SINGLE SIDEBAND

TYPE - SSB-1

ADDENDUM No. 2.

TEMPORARY CORRECTION T-1 TO THE TECHNICAL MANUAL FOR TYPE SSB-1 SINGLE-SIDEBAND RADIO COMMUNICATION EQUIPMENT (NAVSHIPS 92917).

Refer to Transmitter Receiver Schematic (Figure 29-C).

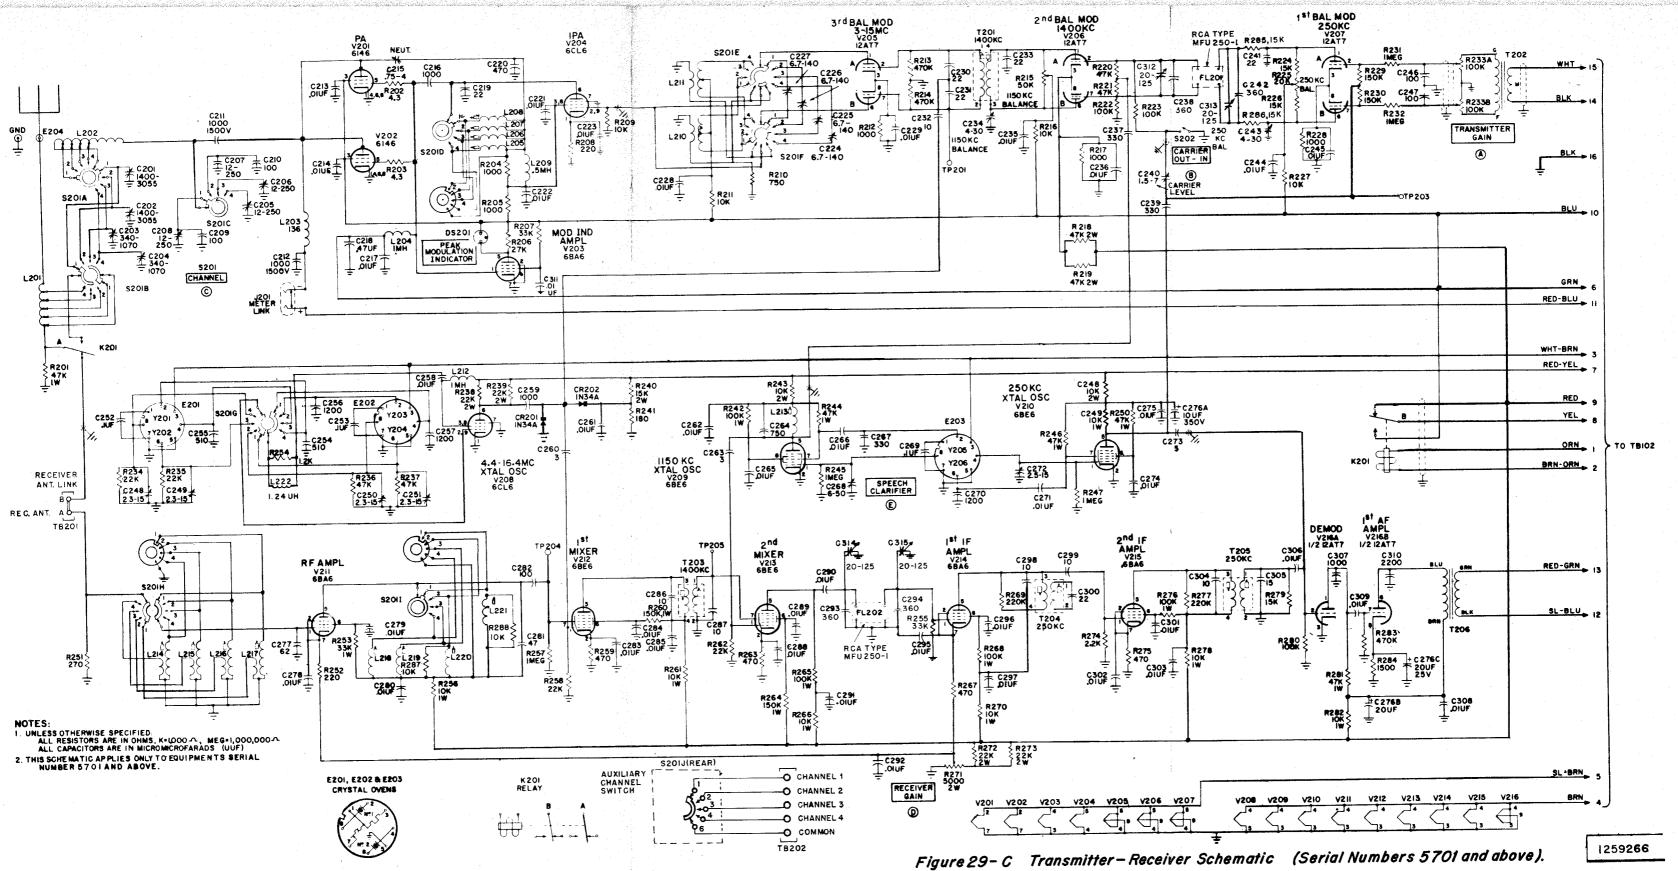
The five additions constituting Addendum No. 2 provide better operation and flexibility for the SSB-l Transmitter-Receiver. Explanation for these additions is as follows:

Item 1. The shorting sections of the switch wafers S201-D, H, and I, remove the unused coils from the radio frequency circuits of the transmitter and receiver, thus reducing losses and improving efficiency.

Item 2. The Auxiliary Channel switch wafer, S201-J is an extension of the channel Selector Switch. The five contacts of this wafer are brought out to a terminal board (TB202). One contact is common to all the other contacts so that a AC or DC current may be applied in series with a control device such as a relay indicator lamp, etc.

Item 3. The Auxiliary Channel Switch Terminal Board (TB202) provides a terminal connection for the Auxiliary Channel switch and any outer contacts required for control operation of auxiliary equipment.

Item 4. The Antenna Link on TB201 is removed when a pre-amplifier for the receiver or a linear power amplifier to follow the transmitter power amplifier is required. The input and output terminals of such amplifiers are connected to terminals B and A.

Item 5. The resistors R287 and R288 connected across L220 and L221 respectively provide greater receiver stability for channels 1 and 2 thus improving reception on these channels.

Figure 3. Cabinet Top Raised and Chassis Withdrawn

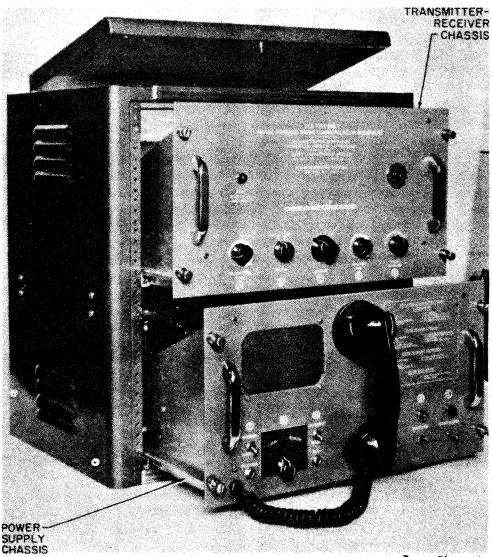
Page	Ref.	Corrections To Be Made
5	LINE VOLTAGE	Delete "230"
5	LAMPS	Change "5" to "2"
7	Figure 3	Paste new Figure 3 over original Figure 3
8	Section I Para. 5	Delete the entire last sub-paragraph.
8	Section I Para. 6	Change the second sub-paragraph to read as follows:
		The equipment operates from 115 volt, 50 to 60 cycle single phase power source and requires approximately 310 watts for full power output. The equipment is connected to the standard navy remote system by a twelve wire cable for the control circuits, and a two wire audio cable for external speakers.
12	Section II Para, 4.h.	Line 3. Change "T-106" to "T-107"
13	Figure 6	Paste new Figure 6 over original Figure 6.
14	Section II Para. 4. h.	Line 10. Change to read as follows: "operation or remote operation."
14	Section II Para. 5	Change sub-paragraph <u>a</u> . to read as follows: <u>a</u> . Input voltage to the power supply circuit is 115 volts, 50/60 cycle. Refer to figure 6.

Figure 17. Power Supply, Bottom View

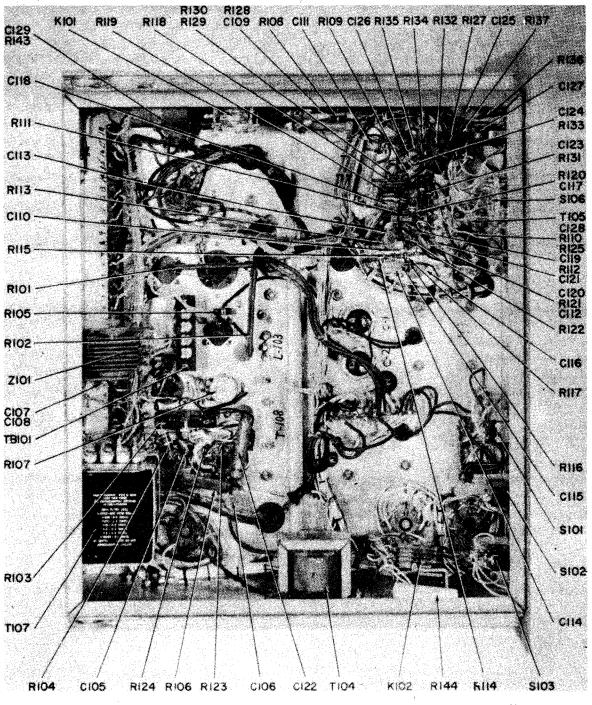
Page	Ref.	Corrections To Be Made	······································
23	Section IV Para. 2.c. (continued)	(3) The standard navy is used for remote open SSB-1 equipment. The monitored by plugging a the PHONES jack. This both transmitted and re The received signal onl tored on the speaker by to SPEAKER.	ration of the system may be a headset into s circuit monitors ceived signals. y may be moni-
24	Table l Power Supply Unit	LOCAL-REMOTE, Column 2. "2".	. Change "4" to
		Column 3. Change line 2 to r	ead as follows:
	· .	"standard navy ren	note system."
24	Table 1 Power Supply Unit	Delete all references to "REN -1-2-3"	MOTE INDICATORS
34	Table 3.	Change TB-103 to read termin respectively. Make correction 3 this bulletin.	
39	Figure 16.	Paste new Figure 16 over origi	inal Figure 16.
40	Figure 17.	Paste new Figure 17 over origi	inal Figure 17.
42	Figure 19.	Delete Figure 19.	
52	PARTS LIST	After C129 add the following:

Figure 1. Desk Installation

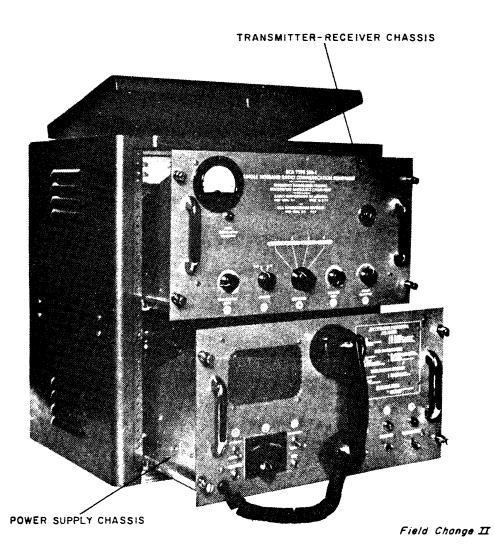
PAGE	REF.	CORRECTIONS TO BE MADE
	Figure 1	Paste new Figure 1 over old Figure 1 inserted by Temporary Correction T-1.
7	Figure 3	Paste new Figure 3 over old Figure 3 inserted by Temporary Correction T-1.
22	Figure 10	Paste new Figure 10 over old Figure 10 inserted by Temporary Correction T-1.
39	Figure 16	Paste new Figure 16 over old Figure 16 inserted by Temporary Correction T-1.
43	Figure 20	Paste new Figure 20 over original Figure 20.
44	Figure 21A	Paste new Figure 21A over original Figure 21A.
45	Figure 21B	Paste new Figure 21B over original Figure 21B.
58	E204	Delete in its entirety.
59	Following J201	Add "J202 - Connector, male, 11 contacts, Box Receptacle type AN3102A-20-33S; Remote Control.
59	Following J202	Add "J203 - Connector, female, Box Receptacle, R.F. Output, type UG-58/U.

Figure 15. Tube Location Diagram

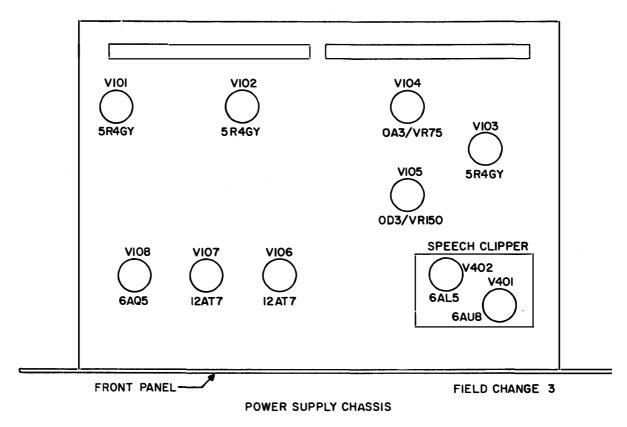
- 29 Figure 15 Paste new Figure 15 over original Figure 15.
- 30Paragraph 4.c.(1)Add the following sentence: "Turn AUTOMATIC GAIN
CONTROL switch to the OFF position.
- 33TABLE 2Make additions as per TABLE 2 (page 6 of this
Temporary Correction).
- 43 Figure 20 Paste new Figure 20 over old Figure 20 inserted by Temporary Correction T-2.
- 44 Figure 21A Paste new Figure 21A over old Figure 21A inserted by Temporary Correction T-2.
- 45 Figure 21B Paste new Figure 21B over old Figure 21B inserted by Temporary Correction T-2.

Figure 6. Power and Control Circuits

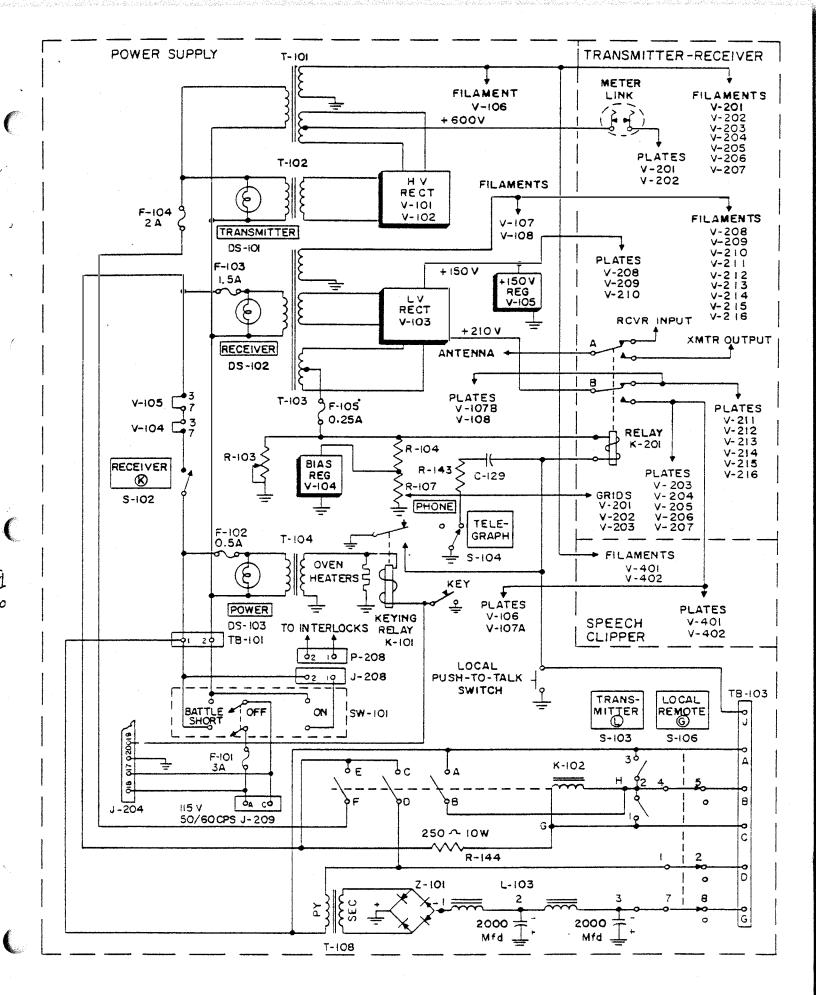
PAGE	REFERENCE	CORRECTIONS TO BE MADE
	Figure 1	Paste new Figure 1 (supplied with this Temporary Correction) over old Figure 1 inserted by Tempo- rary Correction T-3.
13	Figure 6	Paste new Figure 6 (supplied with this Temporary Correction) over old Figure 6 inserted by Tempo- rary Correction T-1.
14	Section II Para. 5 <u>b</u>	Change Para. 5 <u>b</u> to read: "Turning power switch S-100 <u>on</u> , energizes transformer T-104 by way of the cabinet interlock switches and J-208. T-104 then applies power to the crystal oven heaters and keying relay K-101 etc
14	Section II Para. 5 <u>e</u>	Change first sentence to read: "The connections to the switches are such that when the power switch or any of the interlock switches are off, or if J-208 and P-208 are not properly mated, the entire equipment is de-energized, regardless of the positions of the other switches."
14	Section II Para. 5	Add Sub. Para. H: "The interlock circuit is wired in such a manner that the three interlock switches are wired into one half of the AC line through P-208, which is mounted on the back of the cabinet directly behind the power supply chassis. J-208 on the power supply chassis mount must mate with P-208 or the interlock circuit will not be com- plete. To operate the equipment with the power supply partly removed from the cabinet, place the power switch into battle short position, thus disabling the interlock system.
